INTERNATIONAL PRELIMINARY EXAMINATION REPORT

International application No. PCT/EP00/07353

1. The invention concerns an automatic valve intended for installation in the inlet of a thermostatic mixing device.

Fig-1Fig-3Fig-2Fig-4

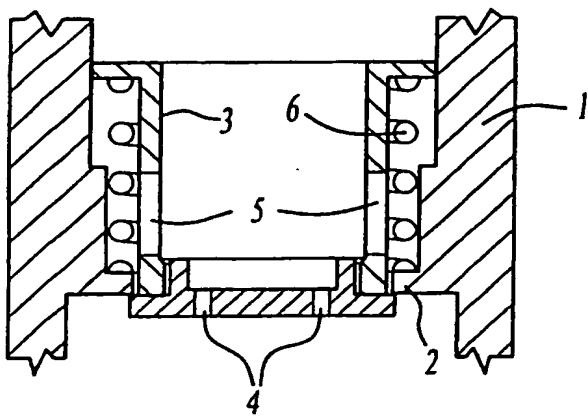
1. Claim 7 states that when the valve is in the first position (ie. closed), the small opening 4 is "up the line" from the seat 2. Looking at figure 1, this appears not to be the case, as the openings 4 are always downstream from the seat 2.
2. Further, claim 7 states that the small opening 4 only becomes pervious when the cursor undergoes a minor shift towards its second (open) position. Looking at figure 1, this also appears not to be the case, as the openings 4 are always open, even when the valve is resting on the seat 2.
